Business Unit: HARTING Electric

PCN/22/012/C+N-US

Product Range: Han-Modular®

Title: Han 200A Module Axial Screw mating side

New 200A axial module

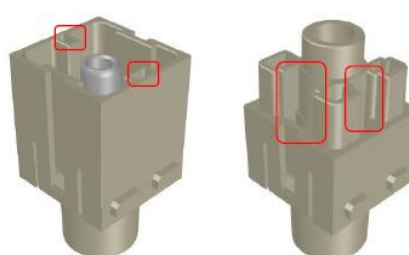
Improvement of the Han® 200A module axial screw mating side ensures mating compatibility with all other 200A and 300A modules.

The modified 200A axial module will also be backwards mating compatible with the present 200A axial module.

The changes are marked red at the below drawings.

The new 200A axial screw male module will get some additional depending, marked red.

Additionally, some outer edges will be smoothened a little to improve the handling.
